Addendum 1

City of Canton, Ohio
Purchasing Department
218 Cleveland Ave. SW, 4th floor
Canton, Ohio 44702

Water Department Service Shop Addition and Renovation

This addendum is a modification of the Bid Document for the Work included for the above named project, and is hereby incorporated into and become a part of said Bid Document. It covers changes and clarification as follows:

DWG
D-100

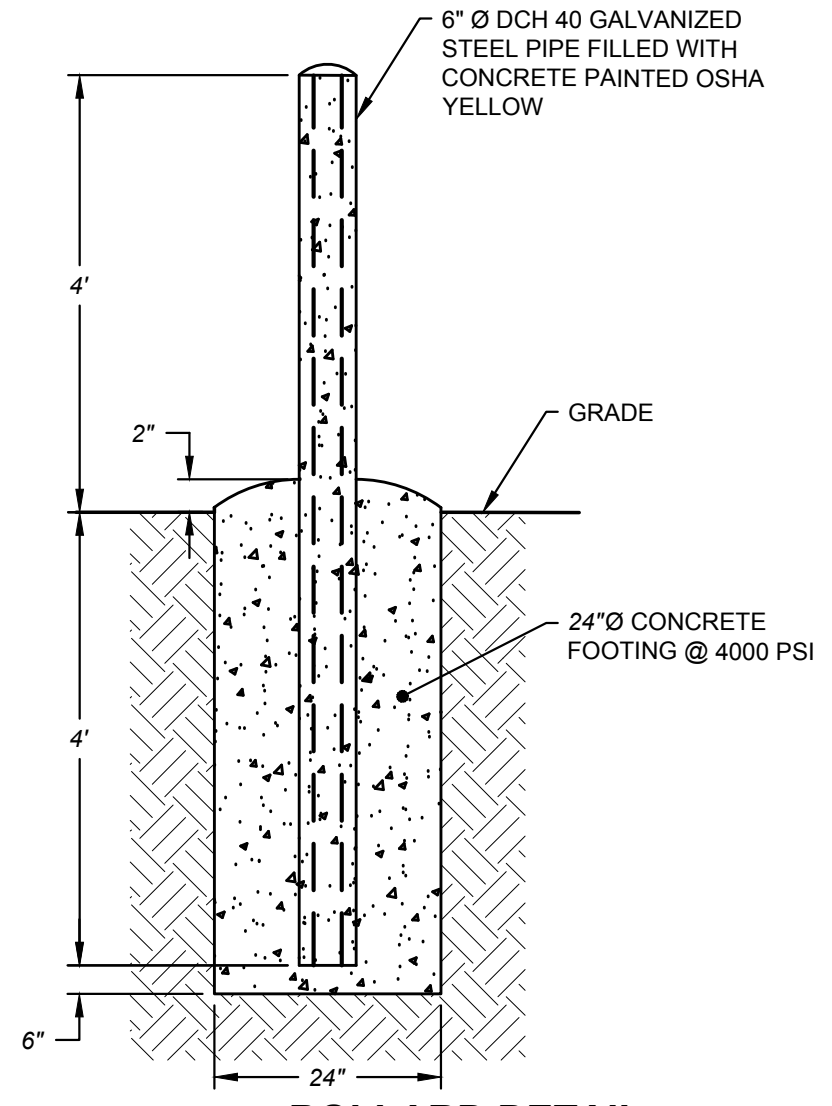
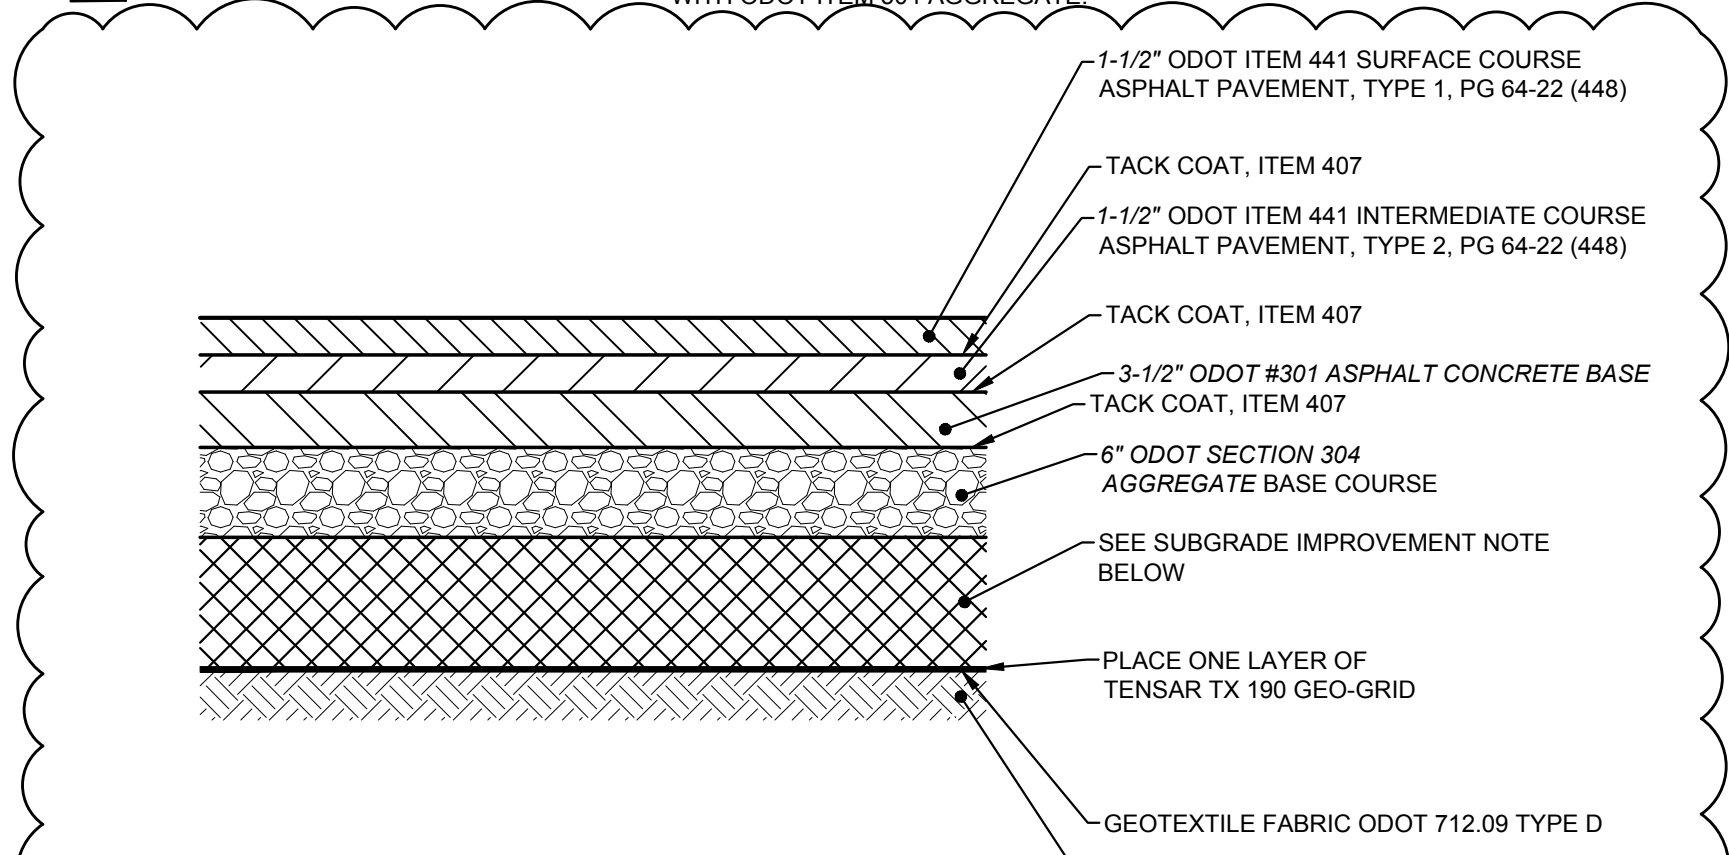
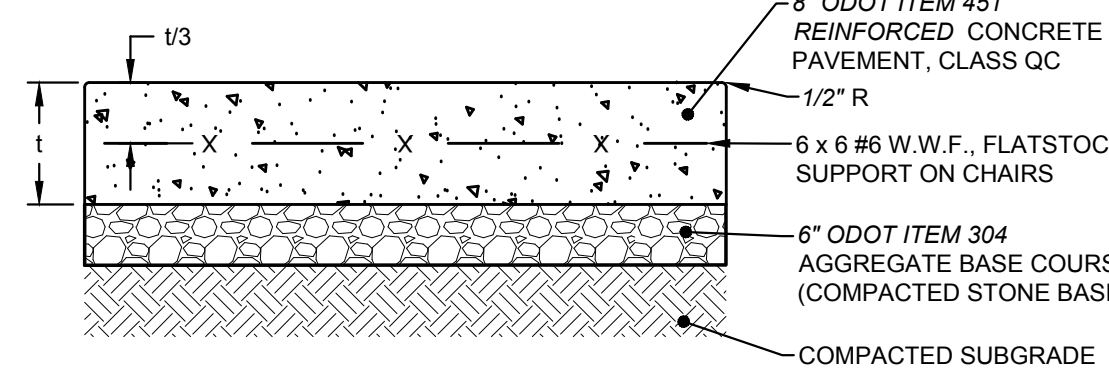
1. DRAWING D-100 – HEAVY DUTY ASPHALT SECTION

- a. Add Heavy Duty Asphalt Pavement Section – See attached.

Terracotta Repair

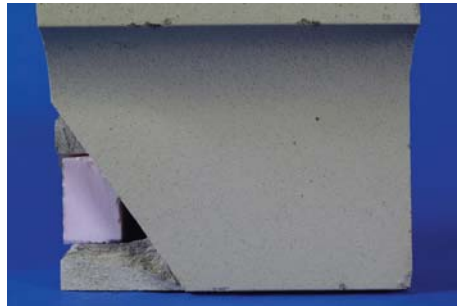
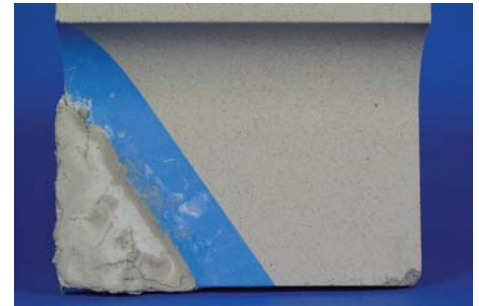
5. DRAWING A-2.2 – PARTIAL FLOOR PLAN – EXISTING SERVICE SHOP

- a. Revise Structural Glaze Facing Tile Repair Note to read:
Clean all SGFT Walls free of scuffs and marks. Patch and repair all damaged locations (holes, broken surfaces, etc.) with materials and process by Conproco, as follows:
 - Clean and prepare damaged materials and surfaces as per manufacturer recommendations.
 - Fill all voids with either extruded polystyrene or expanding foam to provide a backup to apply repair mortar.
 - Repair and finish all locations with recommended system materials for Terra Cotta Repair as published by Conproco.See attached Conproco Terra Cotta Repair Bulletin.
